ADDENDUM #1**Project Name:****Iowa School for the Deaf (ISD) Girls Dormitory Repairs****DAS# 9356.00****RFB 935600-01****Addendum #1****Dated: September 12, 2024**

ADDENDUM # 1

PROJECT DOE ISD Girls Dormitory Repairs

project no. **105023A**
9356.00
RFB #935600-01
sheet
E2.3

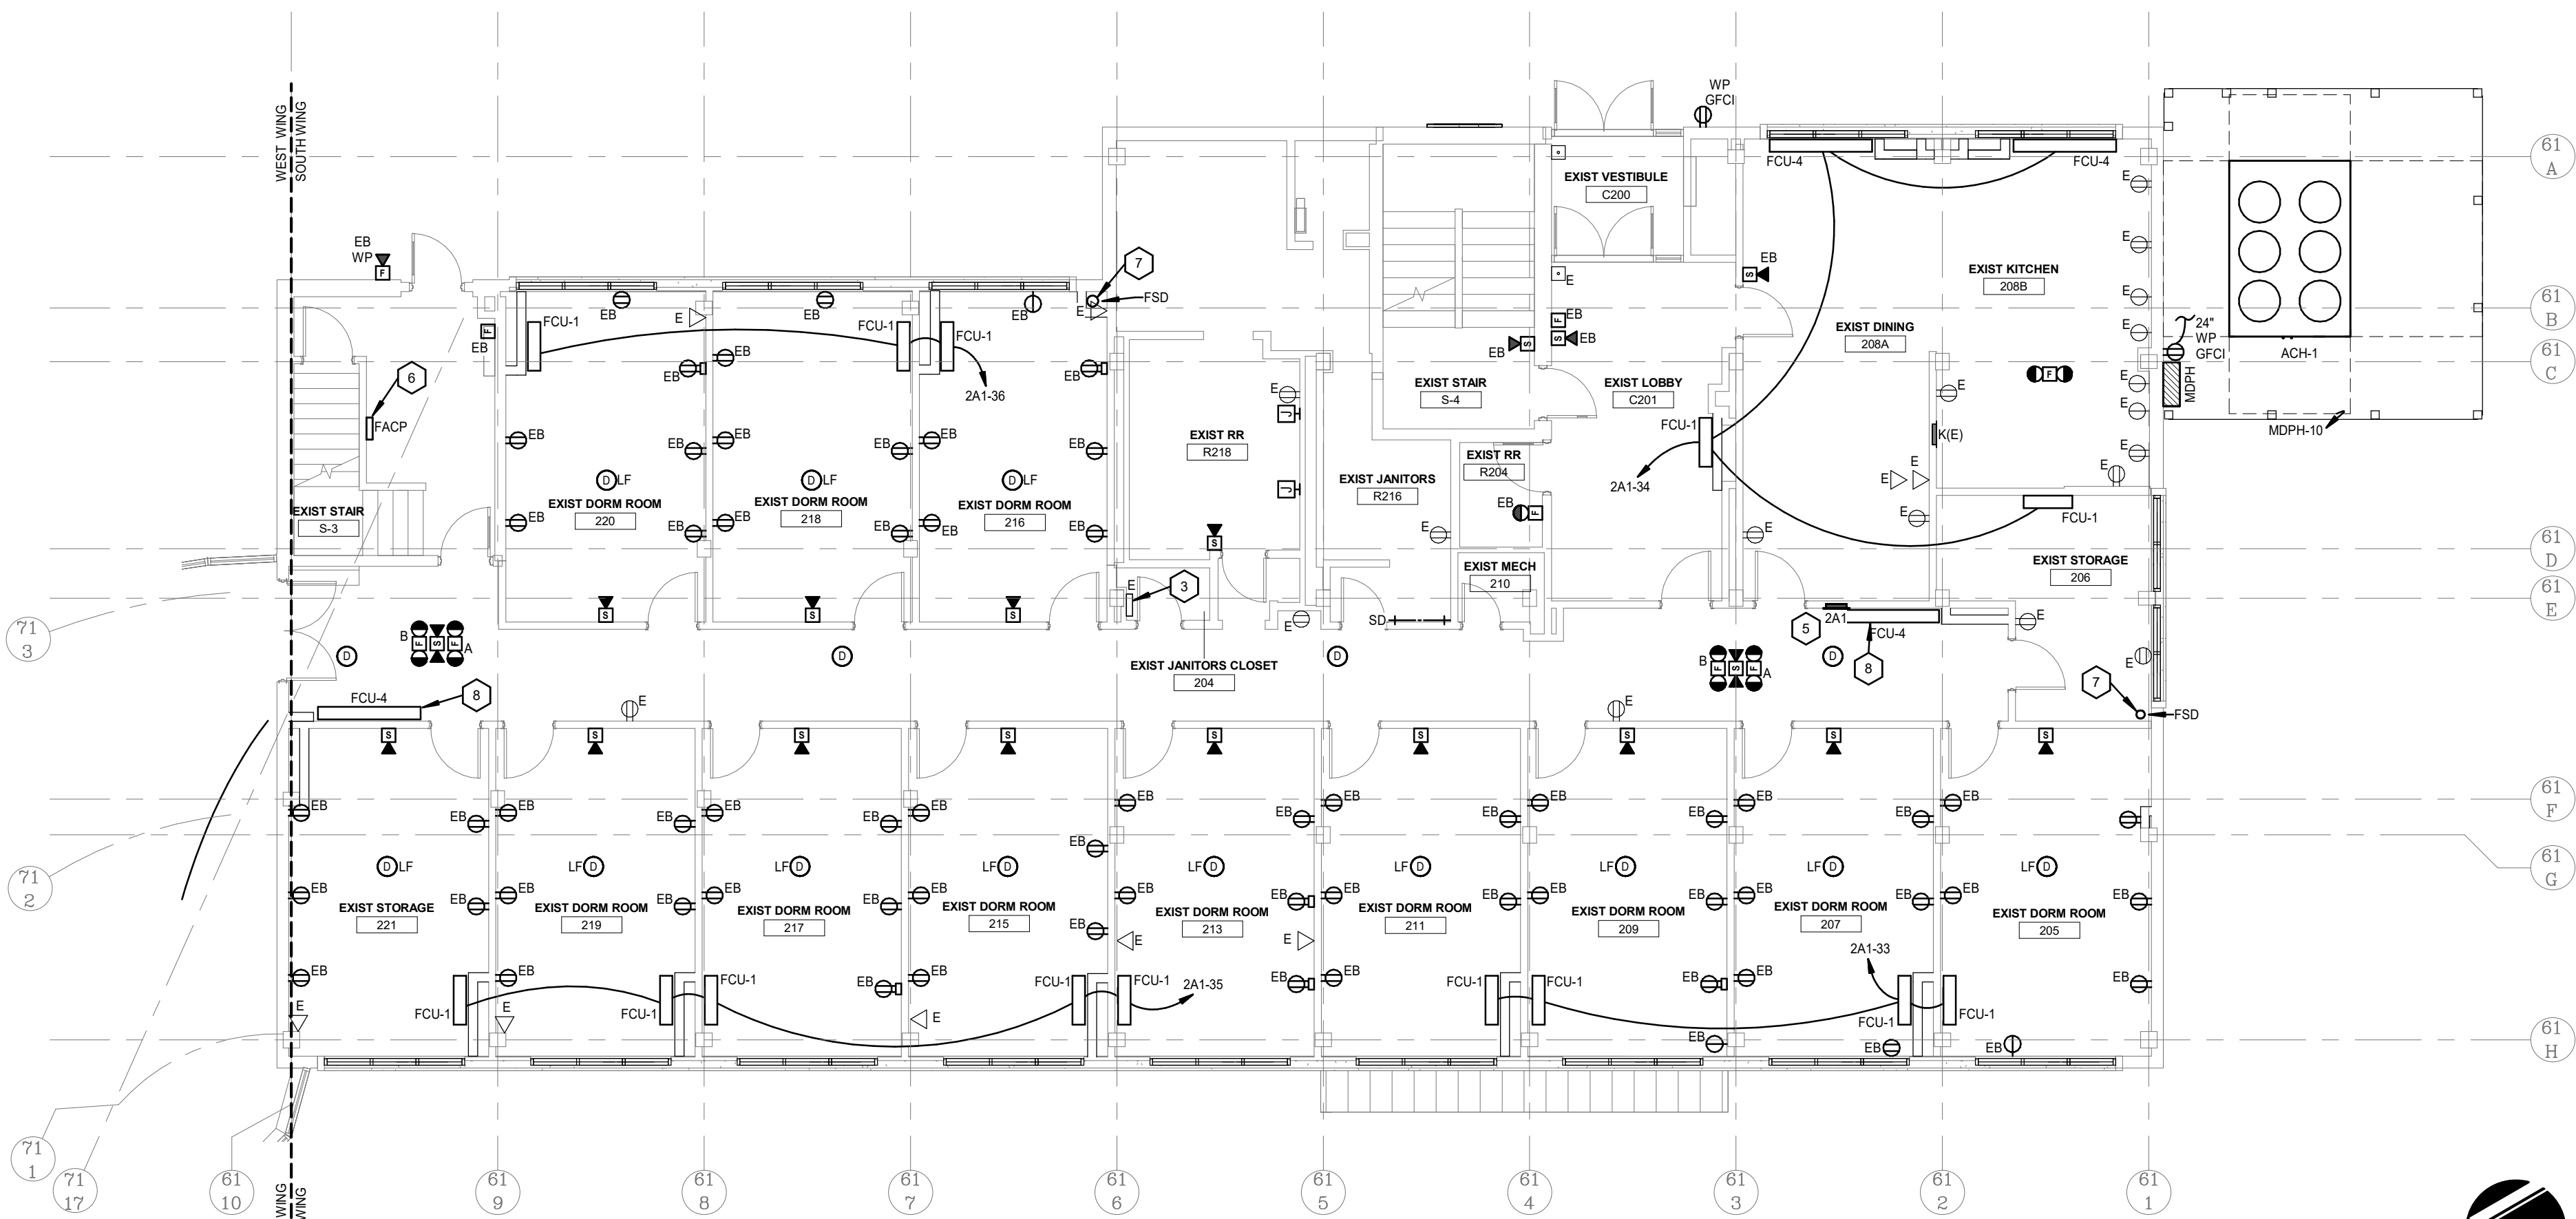
1. Sheet E2.3 Second Floor Electrical Plans
 - A. Revise Sheet Note #8.
2. Sheet E2.4 Third Floor Electrical Plans
 - A. Revise Sheet Note #8.
3. Sheet E5.0 Electrical Schedules
 - A. Equipment Connection Schedule – Add notes for ERV-1 and ERV-1 (ALT).

~~DELETE AS PART OF BID ALTERNATE 1~~
